PROPOSAL: Industrial/Warehouse Building  
 LOCATION: Westgate Business Park, Redymant Rd Uthmaniyah  
 APPLICANT: Uthmaniyah Investment Bank Ltd

Report of Dublin Planning Officer dated 4th June, 1991.

**Re: Planning Application For Two Storey Offices With Single Storey Warehouse  
At Westgate Business Park, Ballymount Road, Dublin 12.**

SCALE 1:500 NO. 9012 201A  
DATE MARCH 1991  
DRAWN G.G.

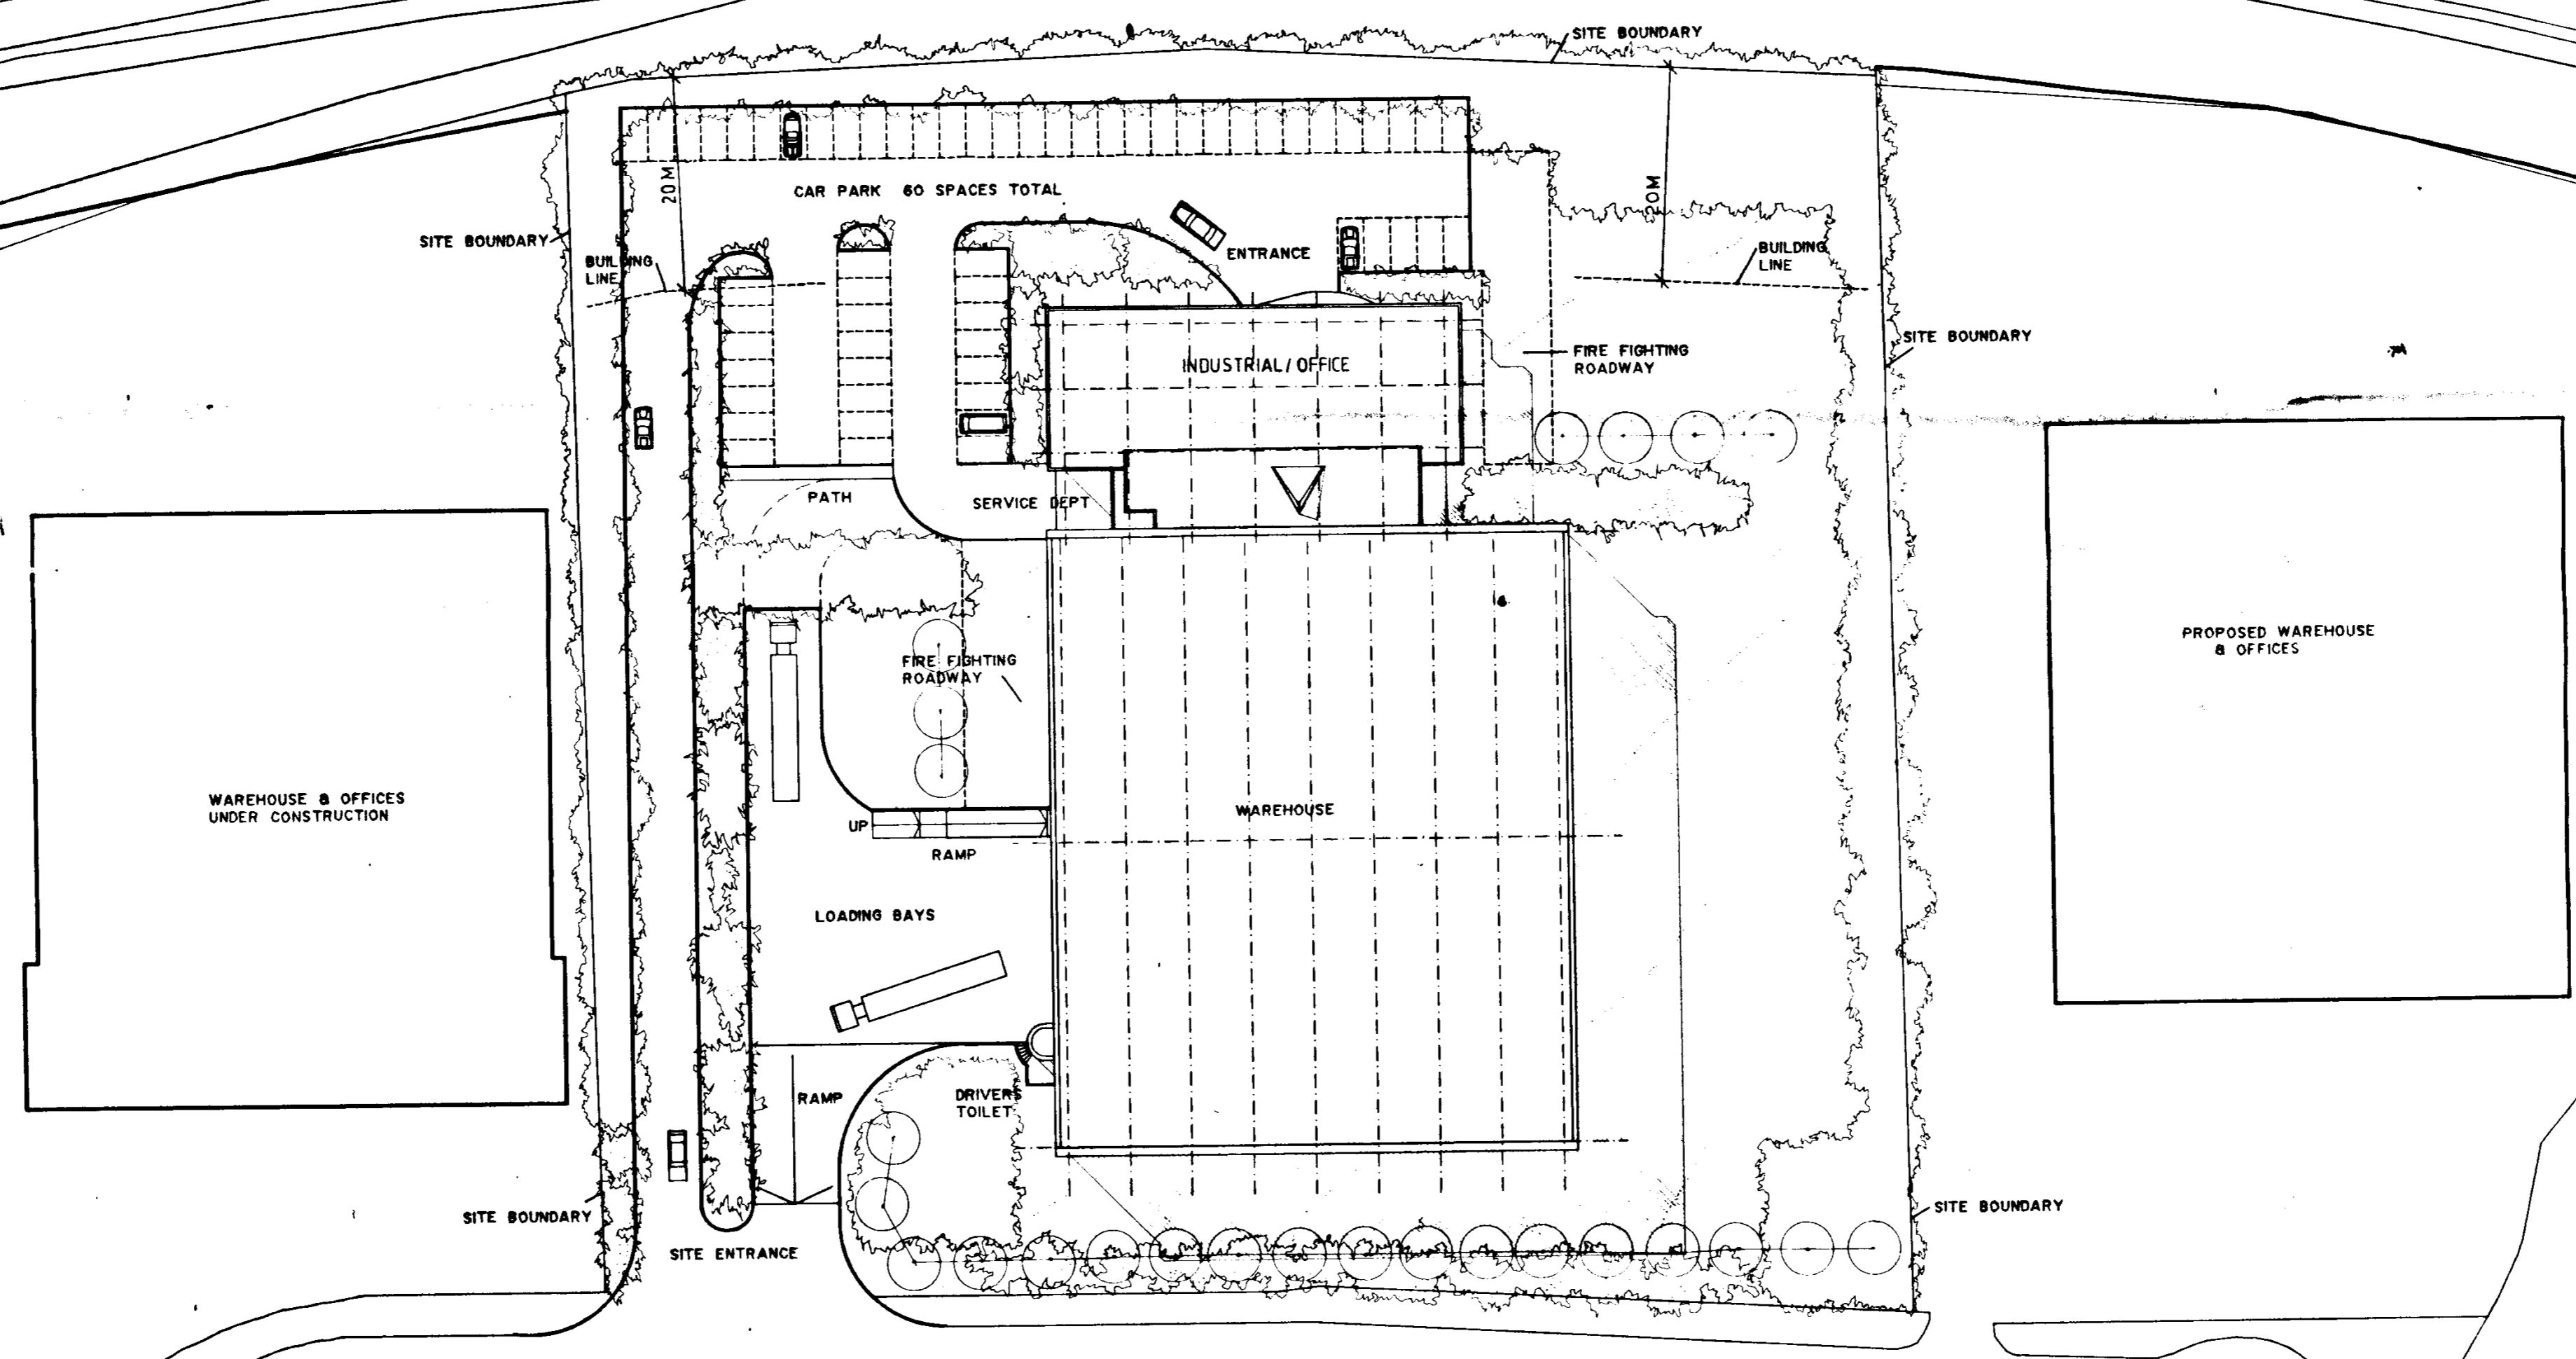
08 That the area which is shown landscaped and is located to the north west of the building on the site plan no. 9012201A dated 15th April, 1991, shall be reserved <sup>for future car parking</sup> ~~(The landscaped area which is the Dublin county council consider that there is a shortfall in the carparking provided in the future shall be laid out as car parking to the requirements of the county council, if/when required by the Planning Authority.~~

SCALE 1:500 NO. 9012 210  
 DATE MARCH 1991  
 DRAWN G.G.

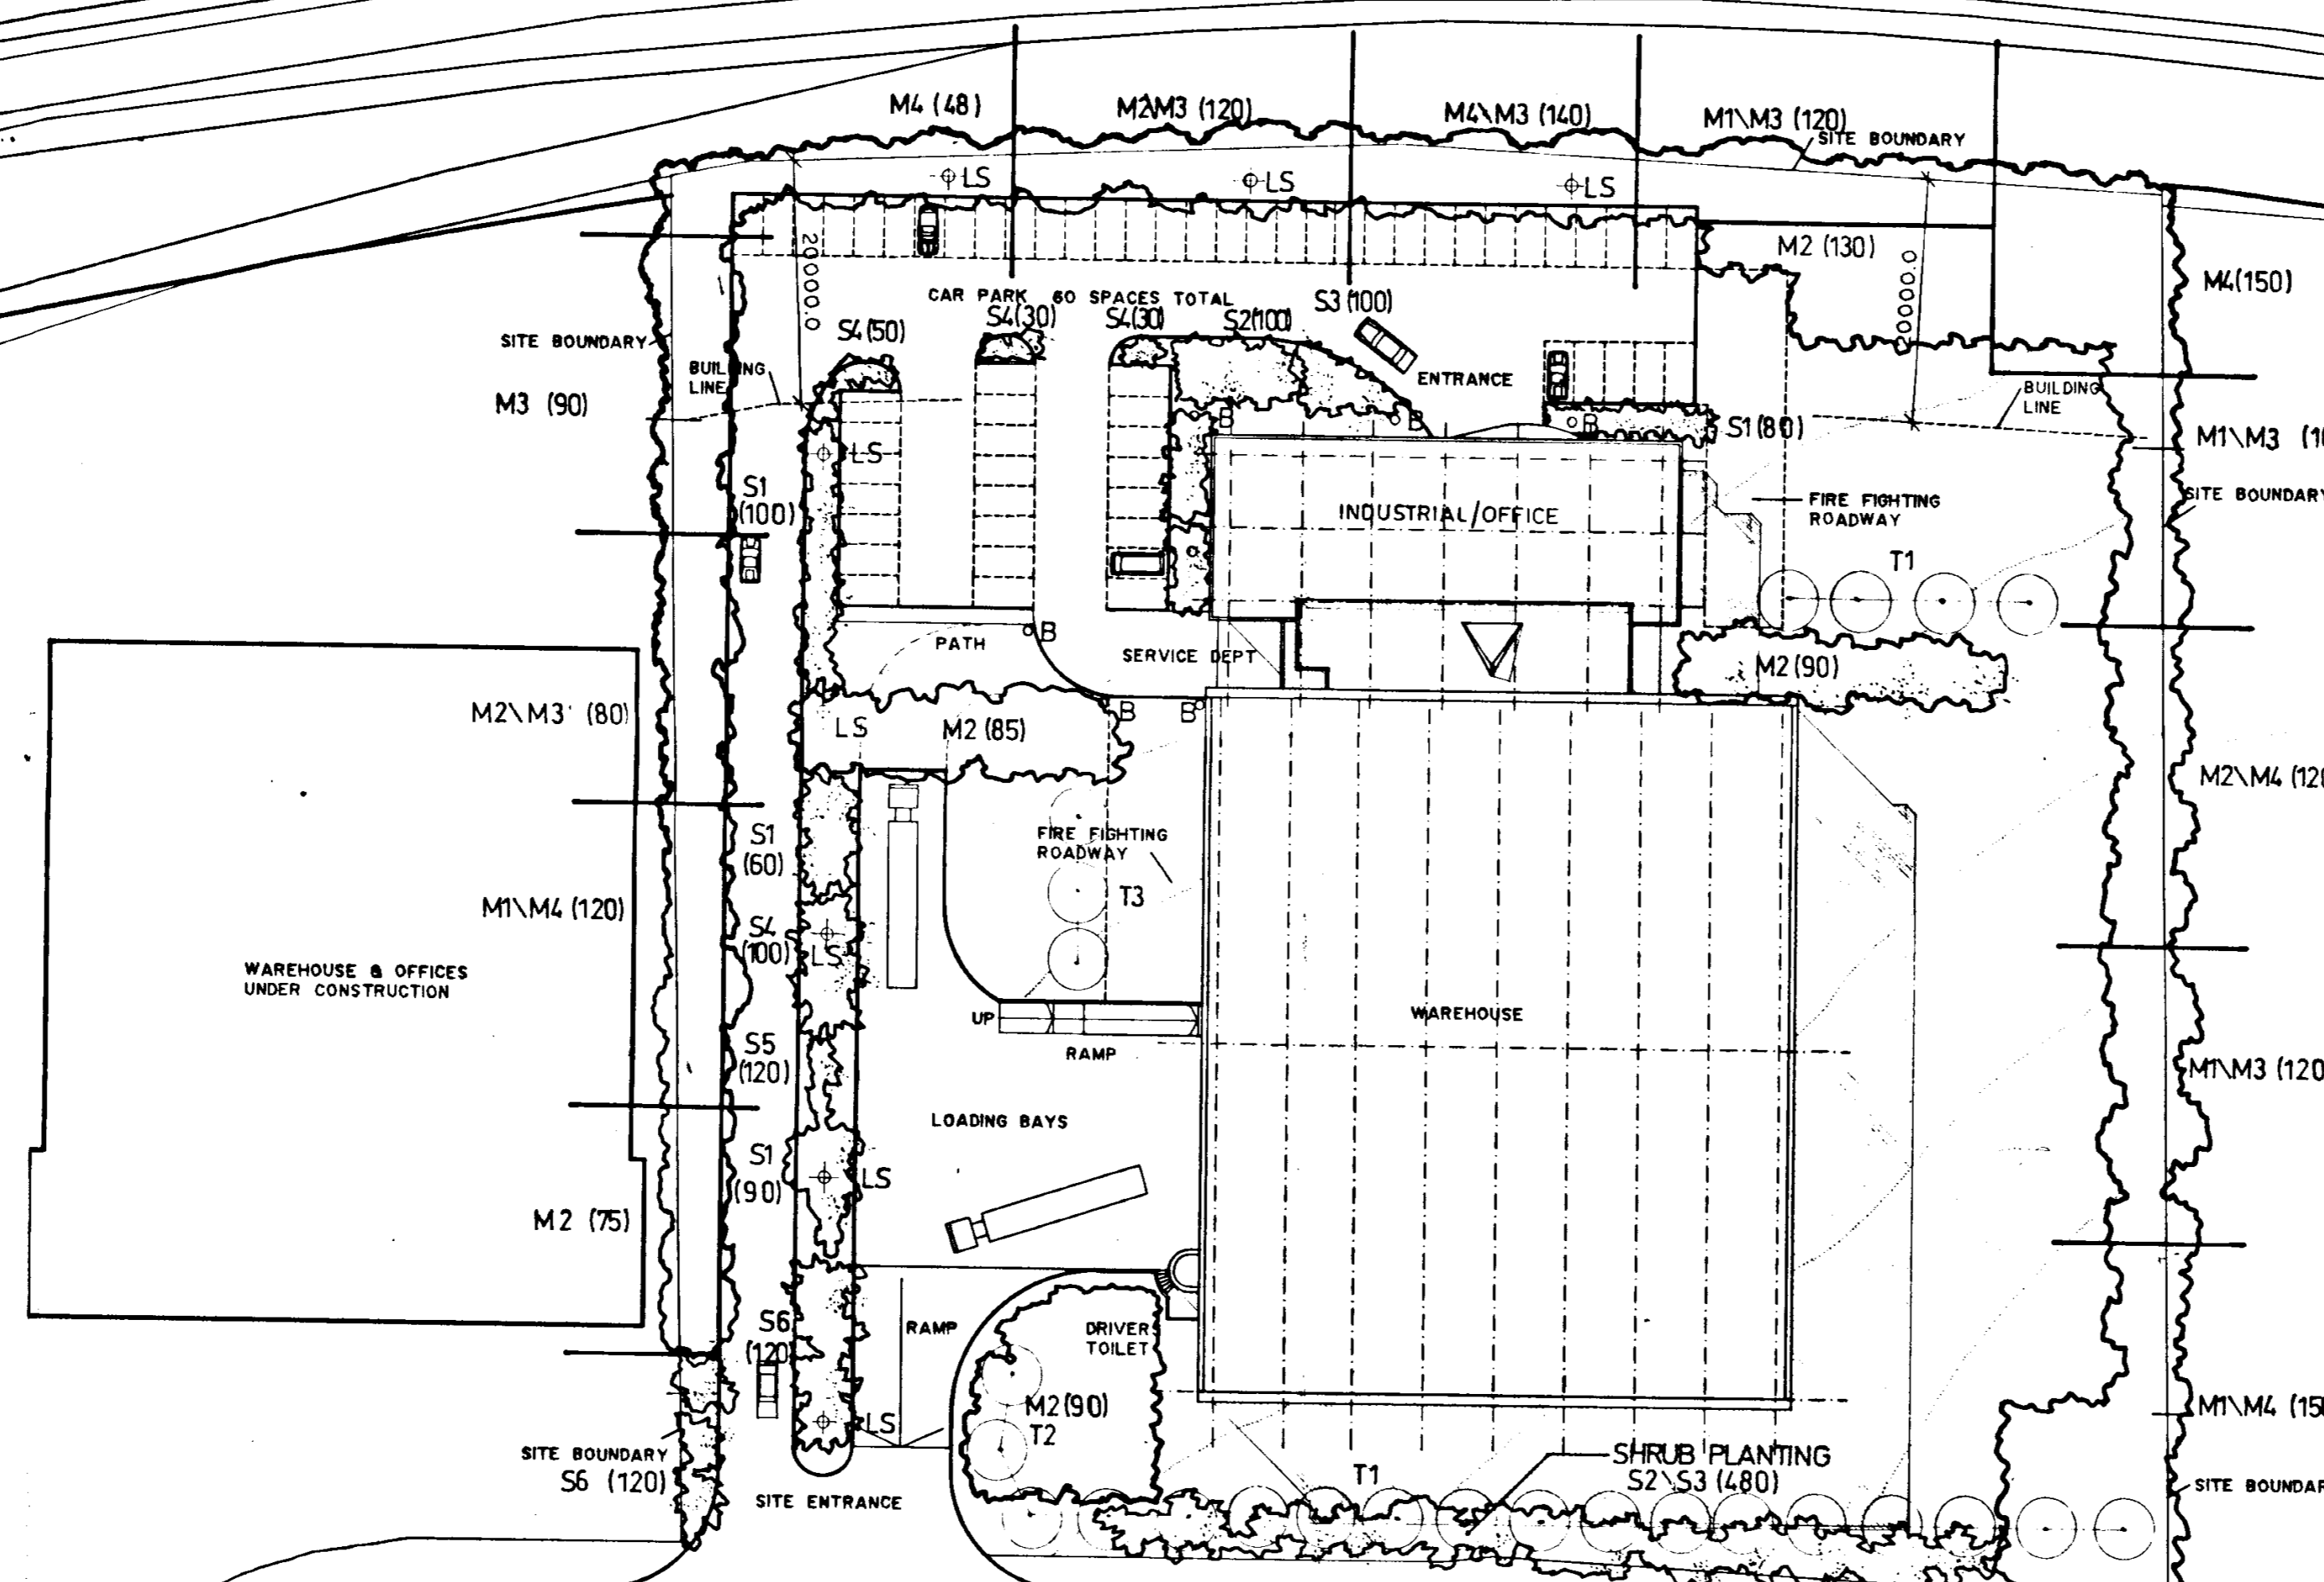
- 1) The landscape plan lodged with this application is unacceptable to this Department as the proposed planting densities along the Motorway boundary are insufficient. The minimum planting density of this location is considered to be 1 plant/m<sup>2</sup>. Furthermore, the percentage mix of each planting group along this boundary require alteration. Overall, the planting density along this boundary needs to be increased by 30 - 40%.
- 2) The absence of a detailed works specification and programme of works is of concern considering the prominent locations of the proposed buildings.

In the above regard, the applicant should be requested to submit a detailed landscape plan, specification and programme of works which should include an increase in planting density of 30 - 40%. Furthermore, the applicant should be requested to submit and agree details of the above, prior to works commencing on site.

The landscaping along the boundary of the western parkway motorway has been agreed with the Parks Department. It mirrors the proposal which was lodged with Ref. Ref. 90A/970. Suitable landscaping is proposed for the remainder of the site. *I note the revised landscaping proposal submitted 21st May 1991.*
